**DRAFT** REPORT

# **Dam Safety Assessment of CCW Impoundments**

## **Luminant Generation Co., LLC/OAK GROVE STEAM ELECTRIC STATION**

February 10, 2014

Photo Number:  
4

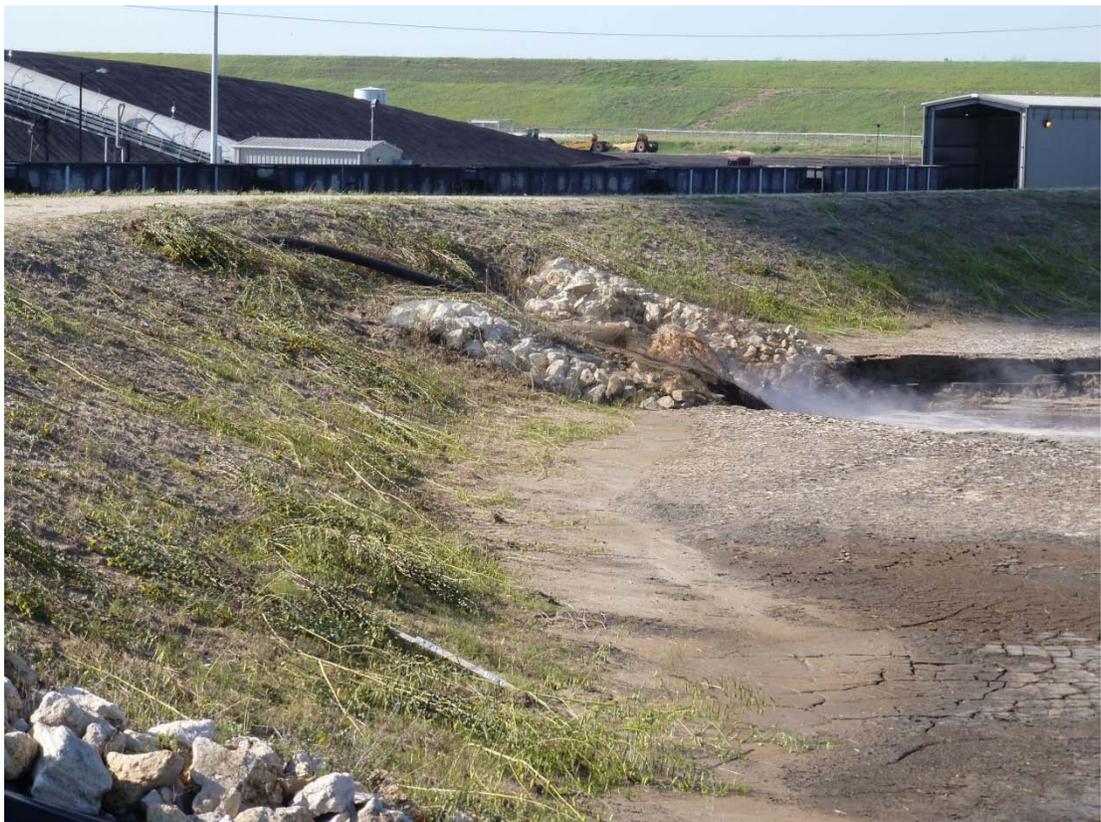
Description:  
CCW discharge into FGD-A Pond.
